DART AEROSPACE LTD	Work Order:	143642
Description: Crosstube Assembly (AS350/355 High Aft SS)	Part Number:	D350-748-243
Inspection Dwg: D350-748-243 Rev: A		Page 1 of 2

DRAWING NO. D350-748-243
SHEET 1 OF 4

TITLE CROSSTUBE (AS 350/355 HI AFT)
SCALE NTS

DRAWING NO. D350-748-243	TITLE CROSSTUBE	REV. A	DART AEROSPACE LTD ENGINEERING ORDER		D.E.O. NO. D350-748-243-A-1	SHEET NO. SHEET 1 OF 1	SCALE NTS
DRAWN <i>q</i>	CHECKED <i>ASS</i>	MFG. APPR. <i>[Signature]</i>	APPROVED <i>[Signature]</i>		DE APPR. <i>[Signature]</i>		
DATE 15.11.18	DATE 15.11.18	DATE 16.02.19	DATE FEB 19 2016		DATE 2016.02.19

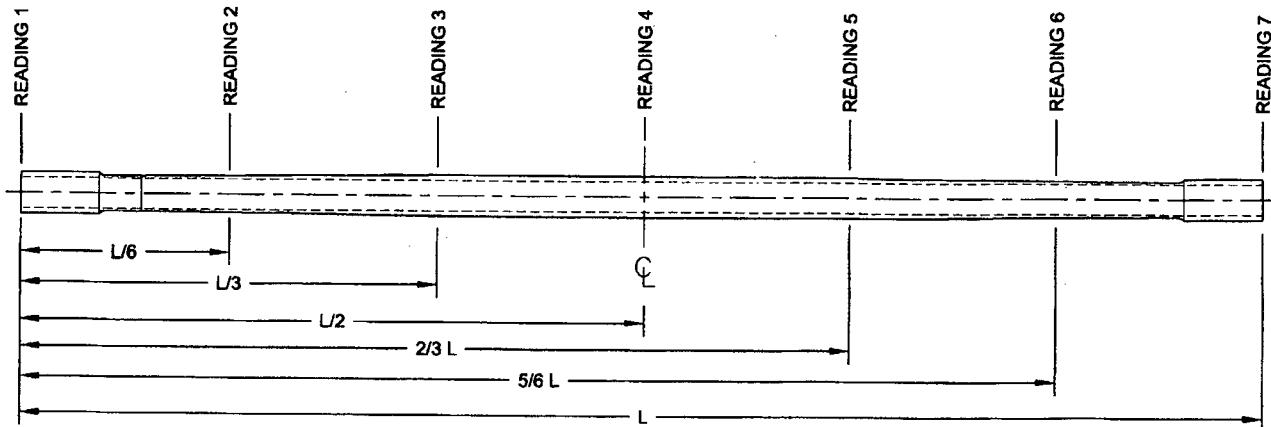
AMEND NOTE 2 (SHEET 1) AS FOLLOWS:

- 2) FINISH: PREPARE SURFACE PER DART QSI 005 4.1.4
 PRIME INSIDE AND OUTSIDE PER DART QSI 005 4.2
 PAINT OUTSIDE PER DART QSI 005 4.2
 OR
 POWDER COAT WHITE (4.3.5.2) PER DART QSI 005 4.3
